Joseph M. Farley Nuclear Plant - Units 1 and 2
Proposed Technical Specification Change
to D.C. Distribution System Requirements

Specific Comments - Battery Technical Specification Change

TABLE 4.8-2

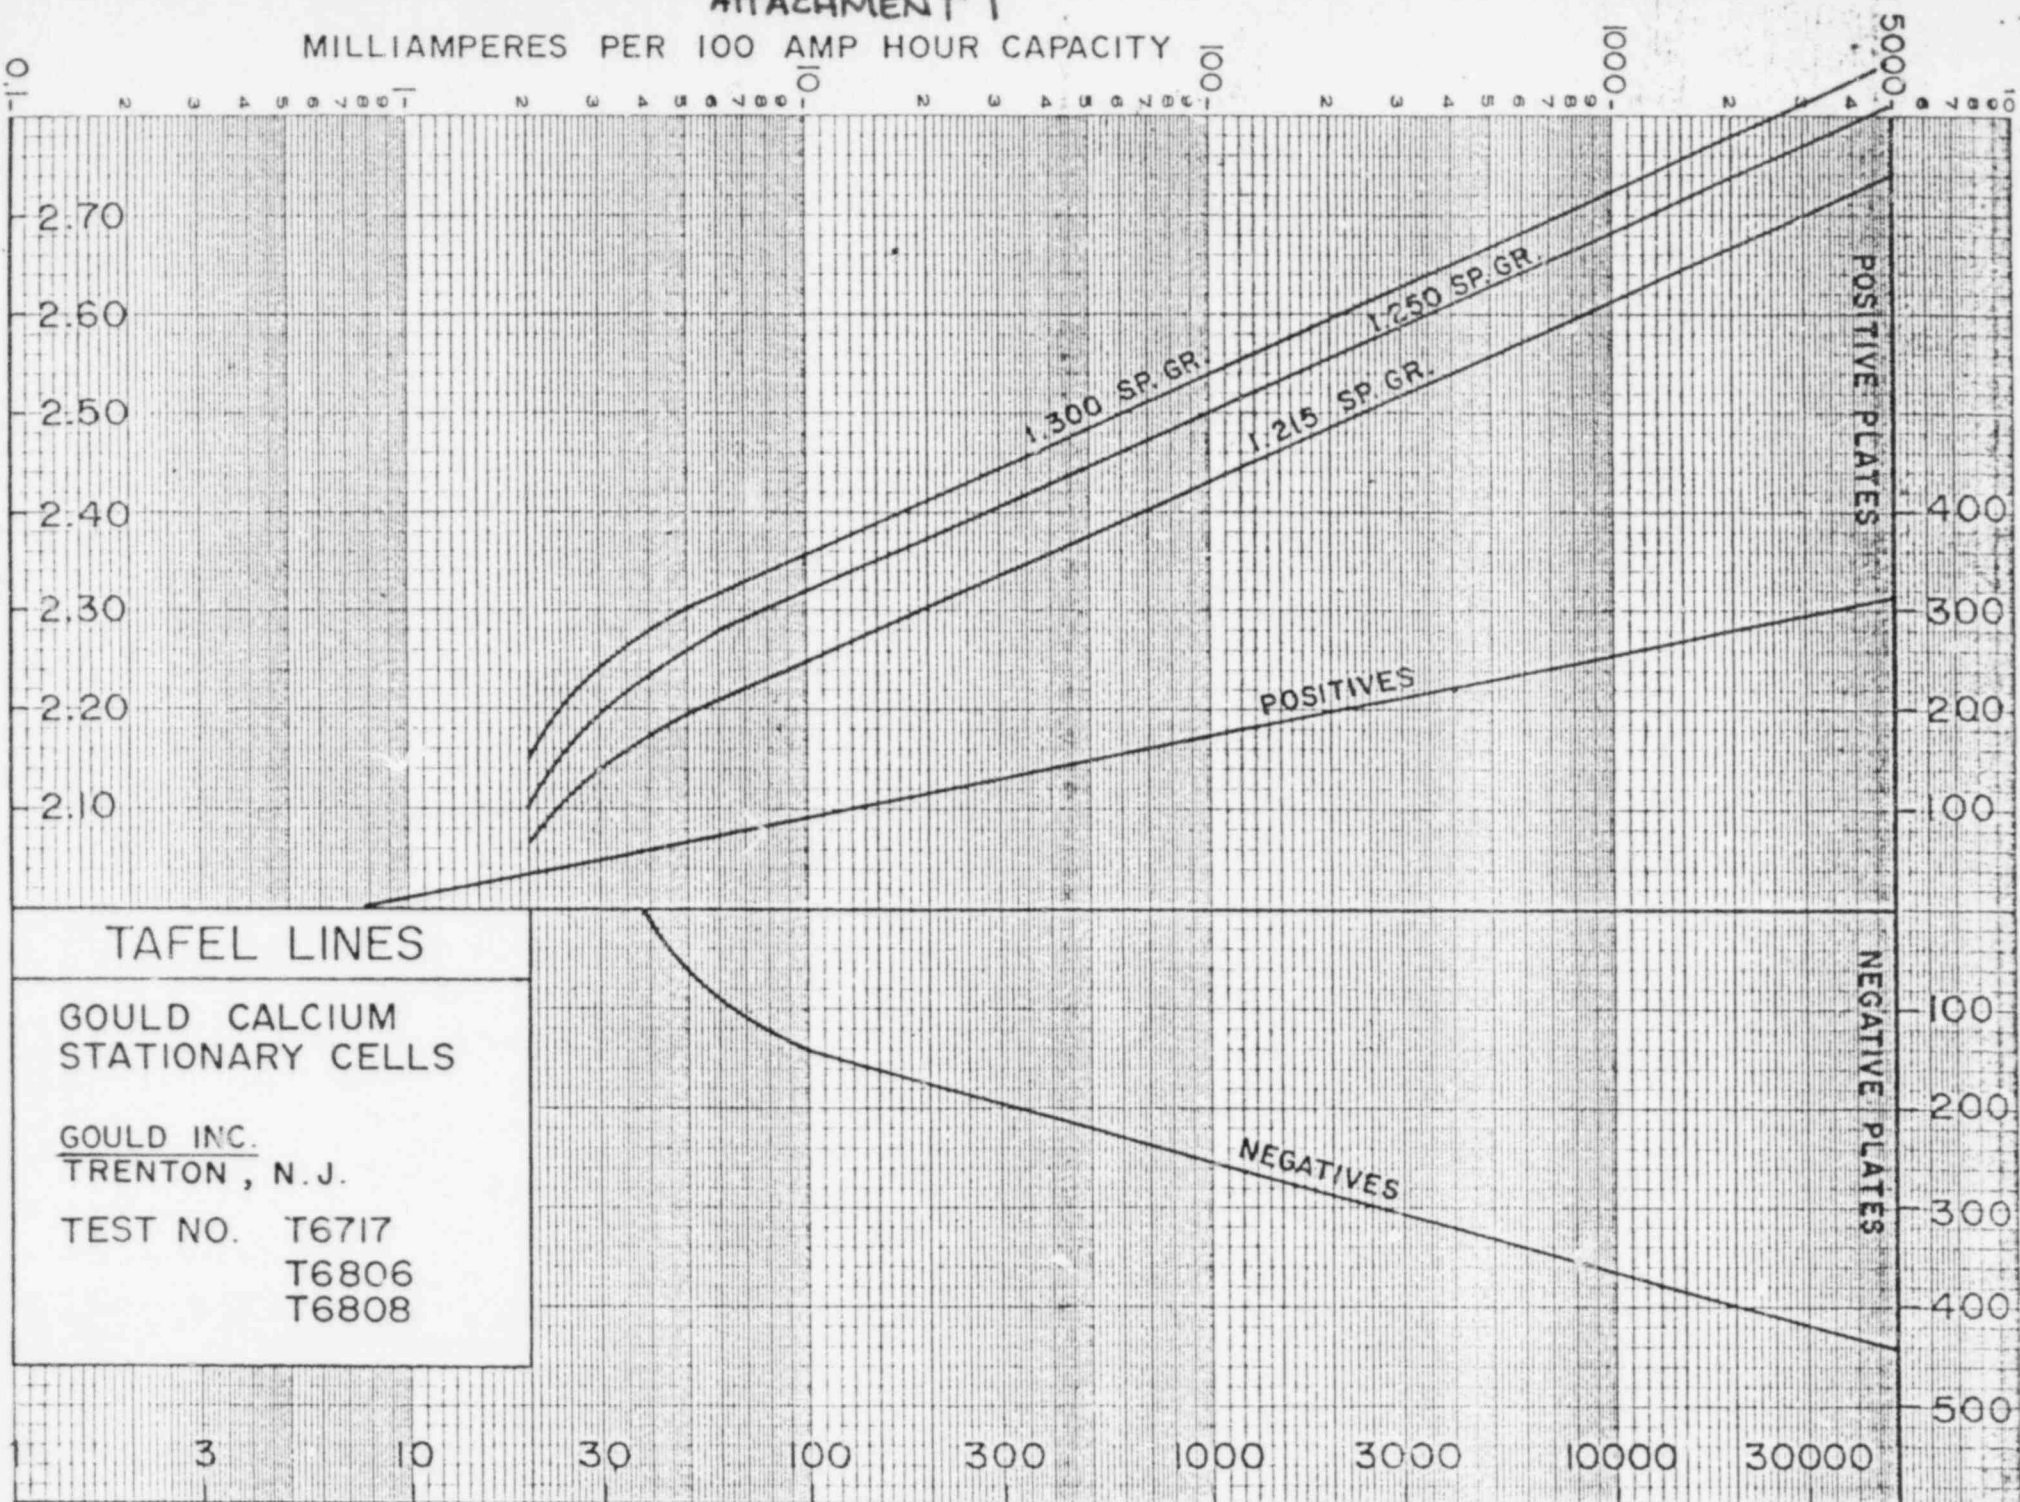
1. NRC Proposed Change

Float Voltage for Category A Limits and Category B Limits should be 2.13 volts vice 2.02 volts and so indicated in T.S. Table 4.8.2.

3. NRC Proposed Change

Specific Gravity for Category A and B Limits should be 1.200 and 1.195, respectively, with the additional requirement that the specific gravity for the average of all connected cells be greater than or equal to 1.205.

4. NRC Proposed Change

Category B specific gravity should have an allowable value of 1.205 for individual cells and an average value for all connected cells of 1.195. The NRC also proposed changing the cell allowable variance from .080 to .020.

APCo Response

The existing Technical Specifications requires a minimum float voltage of 2.02 volts. APCo proposed a float voltage of 2.07 volts in a submittal to the NRC dated May 3, 1983 based upon the guidance of IEEE Standard 450-1980. In accordance with discussions with the NRC Staff, APCo resubmitted, in letter dated January 27, 1984, Table 4.8-2 designating 2.02 volts as the float voltage limit based on the original Technical Specification criteria.

In conclusion, a Category A and B limit of greater than or equal to 2.08 volts with an additional requirement that the average float voltage be greater than or equal to 2.13 volts are considered not only more appropriate float voltage limits, but are enhancements from the existing 2.02 float voltage limit. These limits, considered in conjunction with specific gravity criteria discussed below, are more than adequate to ensure battery operability and capacity.

APCo Response

APCo Response

The NRC proposal to change the 0.080 specific gravity value to 0.020 is acceptable to APCo if the wording of the criteria is modified to read:

".020 below the allowable average (1.190) of all connected cells"

ATTACHMENT 1

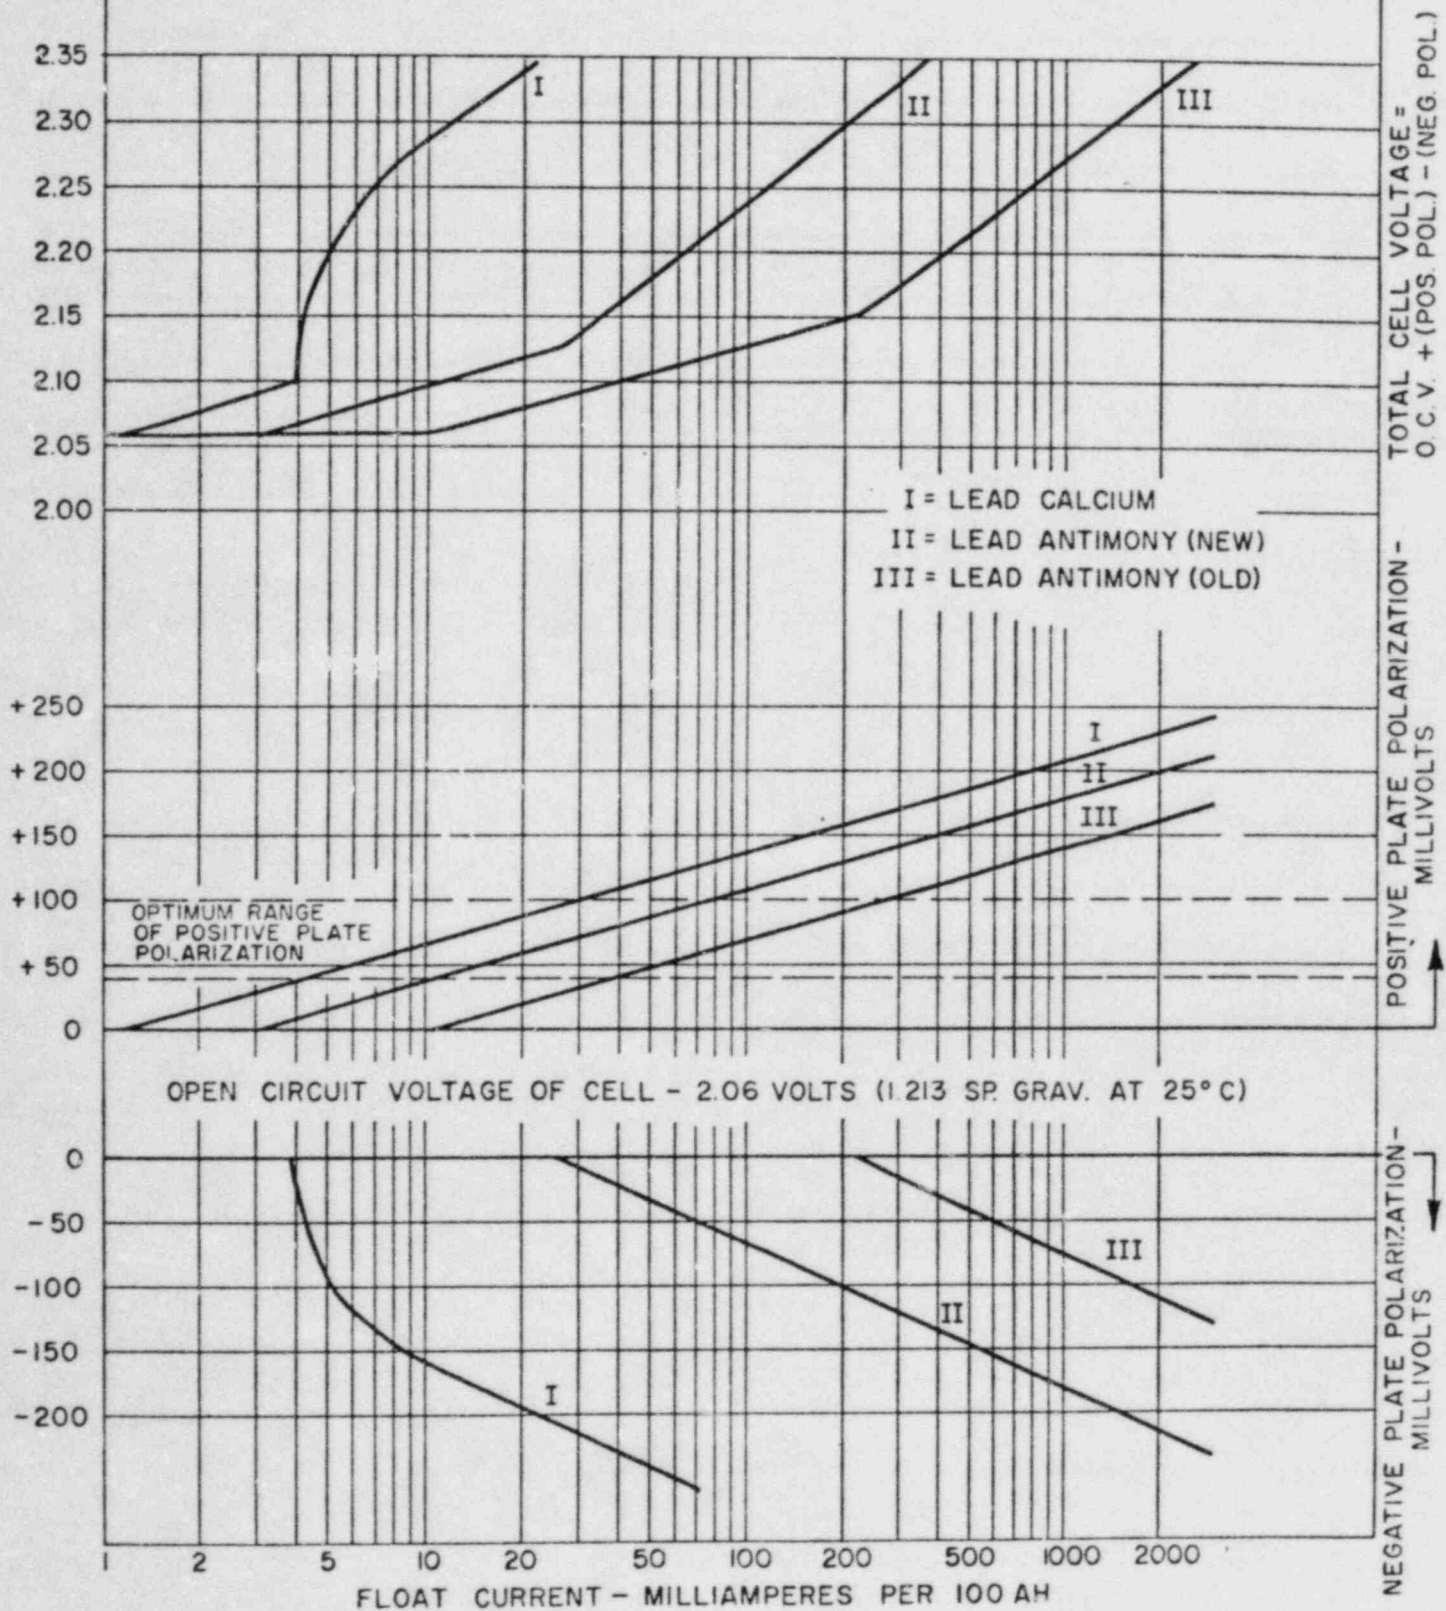
The susceptibility of lead calcium battery cells to variations in float voltage as compared to lead antimony and the reasons for this characteristic are provided in Attachments 1 and 1A which depicts Gould lead calcium cell voltage characteristics and typical lead calcium and lead antimony characteristics. For a Gould lead calcium cell of 1.215 specific gravity, a cell float voltage of 2.2 volts is obtained at a float charge of 5.5 milliamps/100AH. For lead antimony (new battery) this value is typically 63 milliamps/100AH while for an older battery it is over 400 milliamps/100AH. A small change in float charging current of only 3.2 milliamps/100AH on lead calcium cells (e.g., caused by slight battery case leakage due to dust, miscellaneous contamination, or an acidic condition), can cause a cell voltage to drop .1 volts from 2.2 to 2.1 cell voltage. This is below the NRC Proposed value of 2.13 volts and would require, if the NRC value is adopted, APCo to initiate immediate corrective action to equalize voltage. Based on experience at Farley, this is not an indication of a discharge condition, but rather simply a variation in float voltage. Further, the steep slope of the TAFEL Lines of Lead Calcium, shown in Attachment 1 and 1A and comparison of lead calcium and lead antimony float current requirements suggest that lead calcium cells will have a wider float voltage variation per cell than older type batteries (particularly in actual plant environments).

Using Attachment 1, which is applicable to the Farley batteries, negative plate polarization ceases at approximately 2.16 volts and positive plate polarization ceases where no current enters the battery at the open circuit voltage of 2.055 volts. As discussed in Attachment 3, at a positive plate polarization of not greater than 25 millivolts, accelerated positive plate corrosion takes place. Such corrosion seriously degrades battery life if allowed to continue. This value is 2.055 volts, open circuit voltage, plus .025 volts polarization for a total of 2.08 volts. Since this is a value which is critical to overall battery operation, APCo maintains that 2.08 volts is the voltage below which corrective action is required. A value greater than or equal to 2.08 is therefore selected by APCo for limits in Category A and B. It should be further noted, however, that even though a cell may be in jeopardy for the long term at 2.08 volts, the capacity of the battery is still not known until specific gravity is measured. Cell voltage and specific gravity in combination are, in APCo's opinion, accurate indicators of battery condition whereas cell voltage alone is not.

FIGURE 1
TYPICAL DISCHARGE CHARACTERISTICS OF NCX-1800

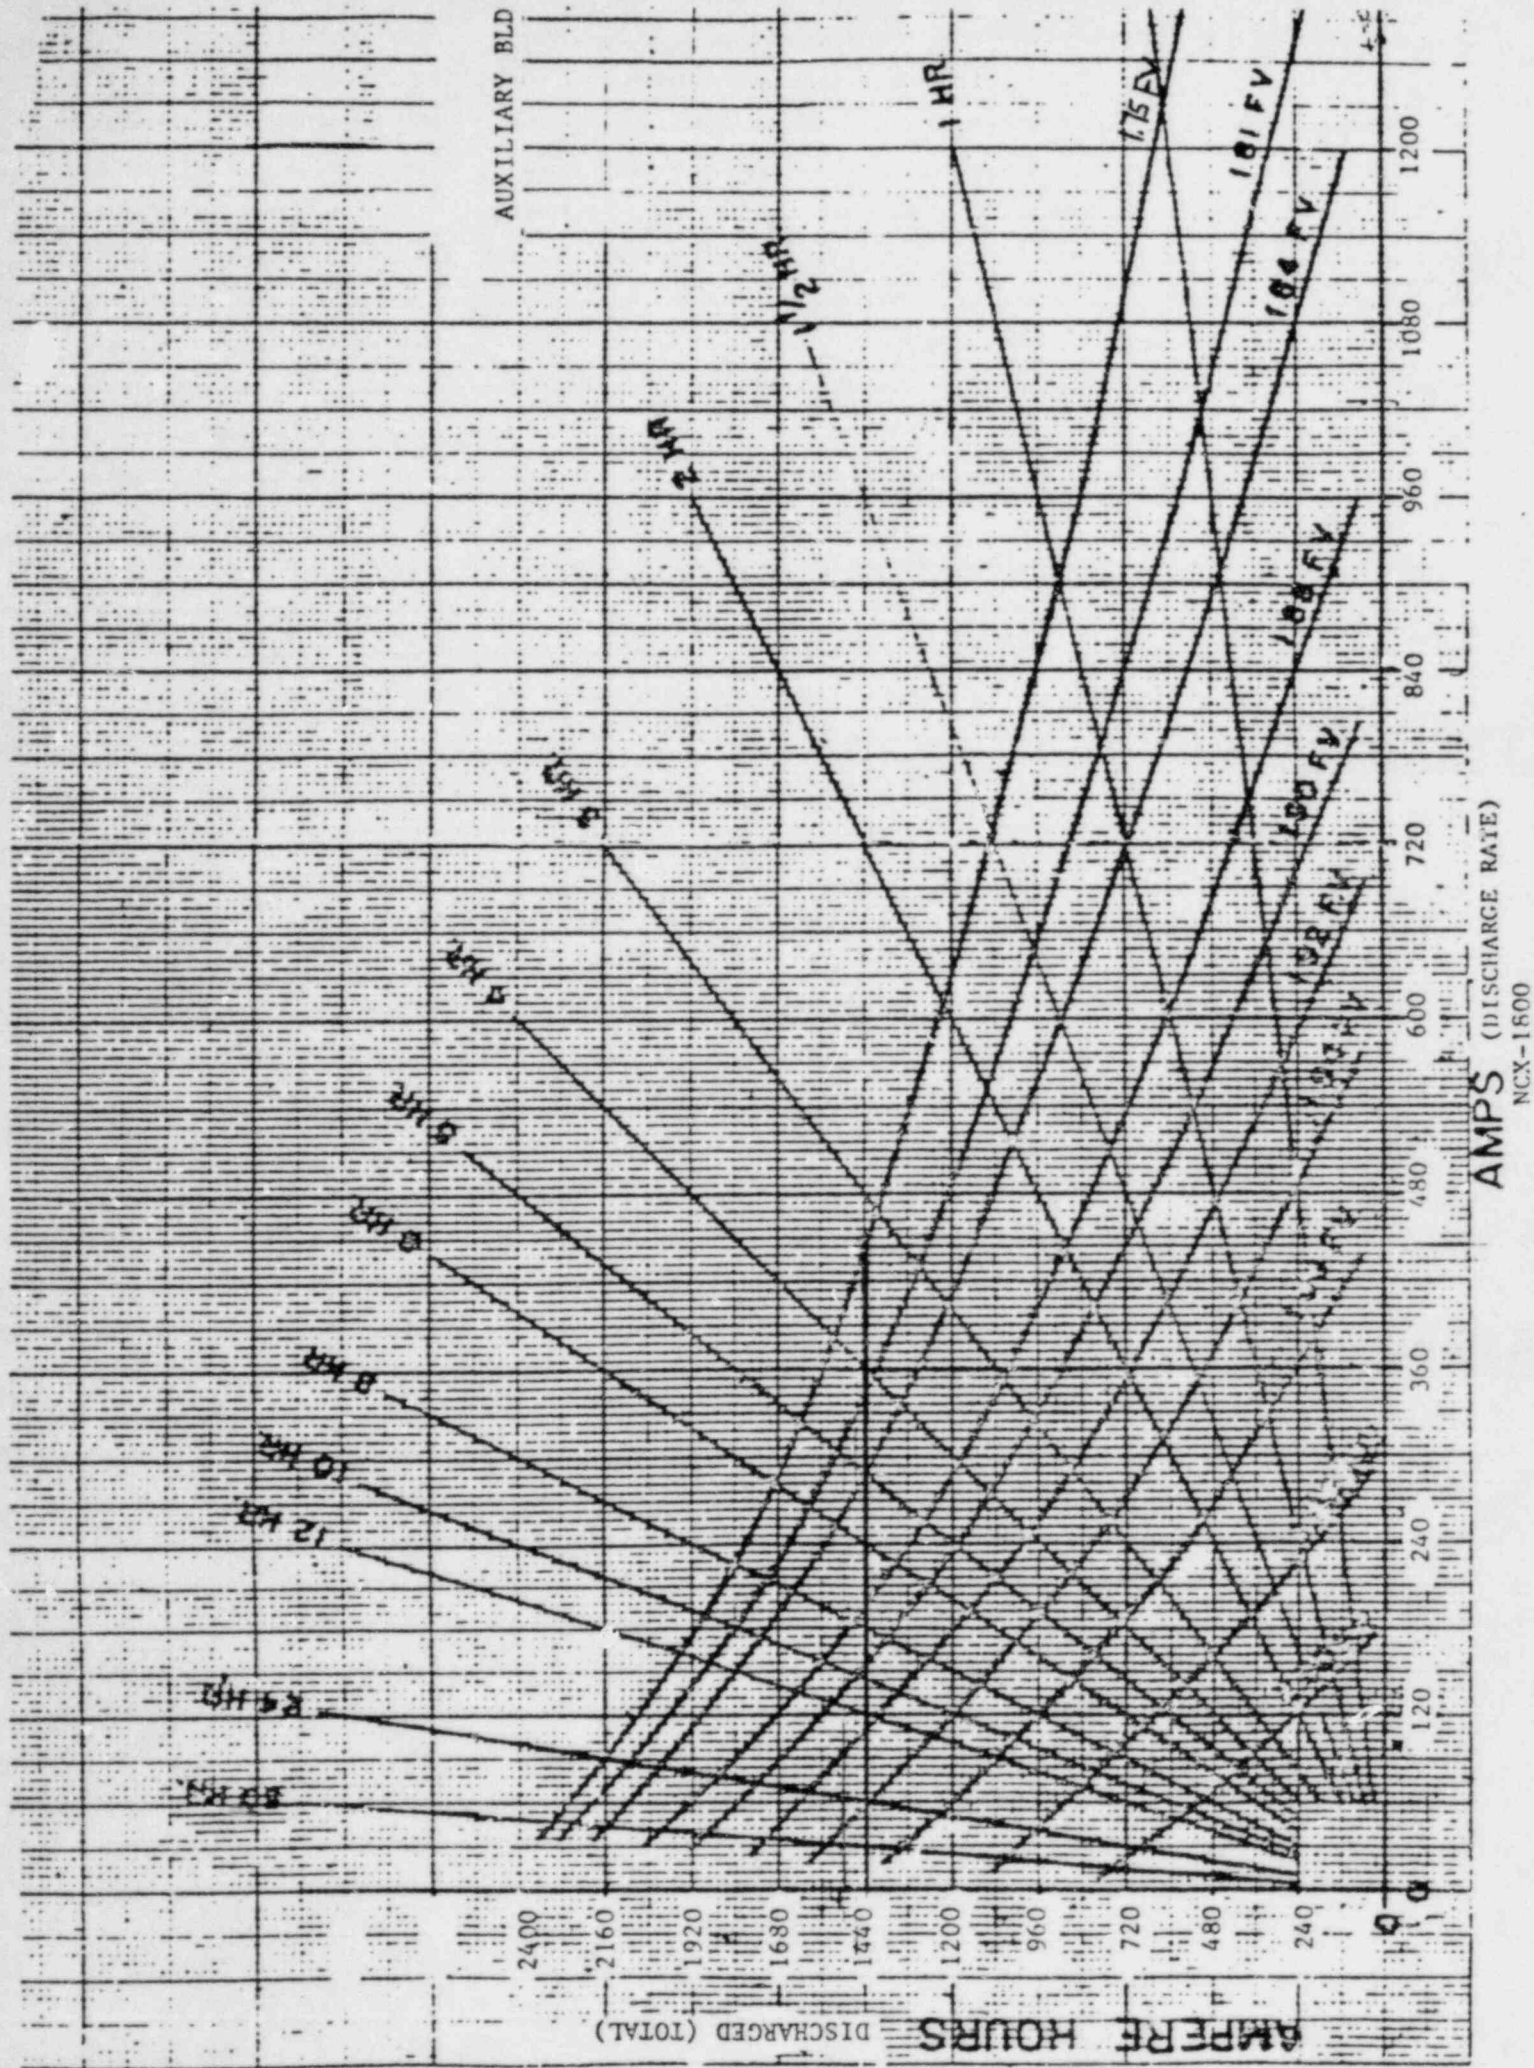
The NRC proposes that the specific gravity for the average of all connected cells be greater than or equal to 1.205. APCo proposes that the specific gravity be 1.195 which is based on the FSAR required loads plus an adequate margin of 16%. The minimum average specific gravity to meet the FSAR loads is approximately 1.181 as shown in Figure 2 of Attachment 4.

2. Using the manufacturer's discharge curve for the NCX-1800 (See attached Figure 1, Typical Discharge Characteristics of NCX-1800) and the average discharge rate of 442 amps, the total amp hours available is 1440. The availability of 1440 amp-hrs in the battery is obtained by selecting 442 on the "X" axis, extending vertically until the 1.75 volt (FSAR 8.3.2.1.1) line is intersected, and then extending left horizontally to the "Y" axis where Amp-Hrs. (AH) is read as 1440. Note that the 442 amps is an average discharge rate. We consider this to be a conservative (on the high side) rate since battery characteristics are such that the lowest discharge rate, 430 amps in this case, should be used which would provide for a capacity total of over 1440 AH by using the same process as before, only starting at 430 amps on the "X" axis.

3. The FSAR loads are therefore equal to 61% of the Auxiliary Building Batteries Capacity and therefore there is approximately a 40% margin within the battery.
